1985 Corvette: Service News: Revised Differential Case Cross Pin Installation Procedure

Subject: Revised Differential Case Cross Pin Installation Procedure

Model and Year: 1985 Corvette

Source: Chevrolet Service News

Fig. 4 — Installing Cross Pin

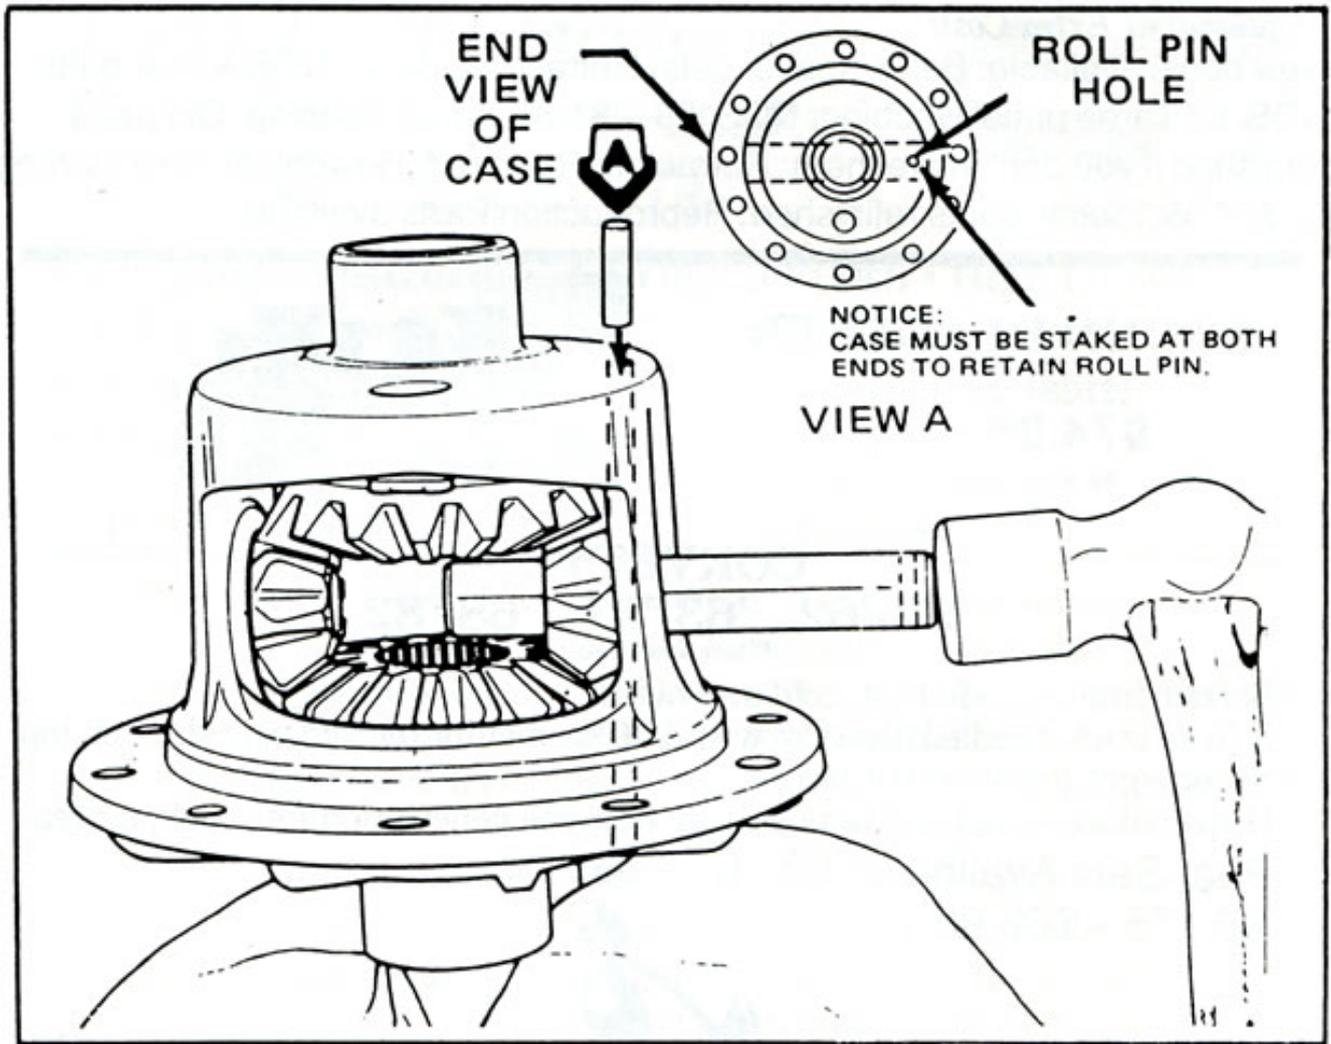
Figure 4B-39 shown on Page 4B-16 and step 10 shown on Page 4b-17 of the 1985 Corvette Shop Manual (ST-364-85) have been revised as indicated below. Fig. 4 replaces Figure 4B-39 presently shown in the Shop Manual.

10. Position the cross pin shaft in the case and drive in with a hammer. Be sure the retaining pin hole of the cross pin shaft is properly aligned to allow installation of the retaining pin. Install the retaining pin to the proper depth using a punch and stake in place at both ends of the case.
